Meeting Minutes Transmittal/Approval
Unit Manager's Meeting: 100 Aggregate Area/100 Area Operable Units
740 Stevens Center, Room 1200, Richland, Washington
June 23, 1993

**Unit Manager's Meeting: 100 Aggregate Area/100 Area Operable Units
June 23, 1993**

RESPONSE TO ECOLOGY COMMENTS ON THE 100 AREA EXCAVATION TREATABILITY TEST PLAN DOE/RL-93-04, DECISIONAL DRAFT

RESPONSE TO EPA COMMENTS ON THE 100 AREA EXCAVATION TREATABILITY
TEST PLAN DOE/RL-93-04, DECISIONAL DRAFT

Figure 1. 100-DR-2 Borehole Sites

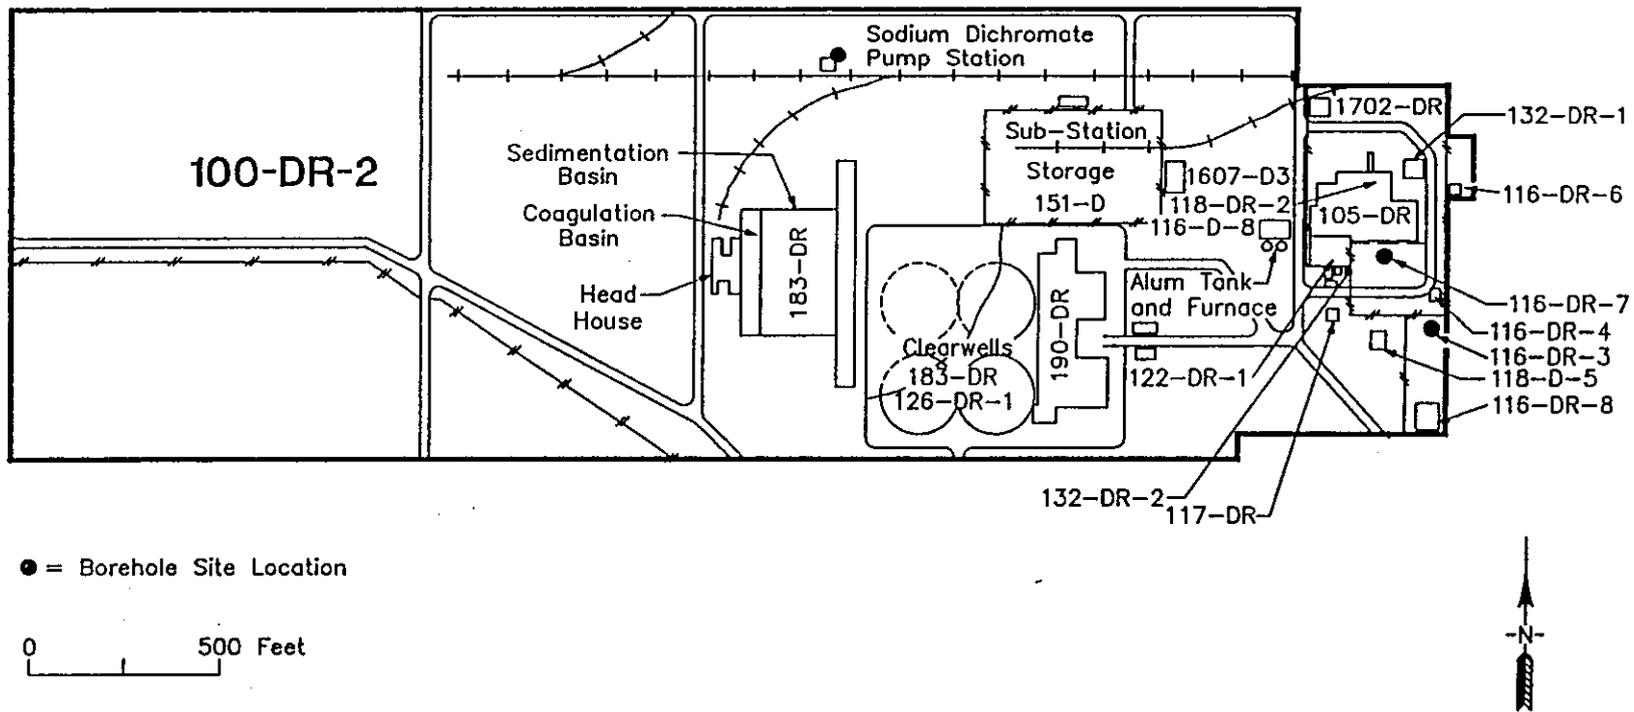
- (1) During the site walk Eric Goller requested specific geophysical method(s) to be used in locating or confirming each waste site. Westinghouse promised to provide a table describing the geophysical methods to be used for each waste site. This table is attached.
- (2) Ted Wooley made a comment that he would like to review the information provided to him during the site walk and get back to us after receiving the field notes of the site walk.
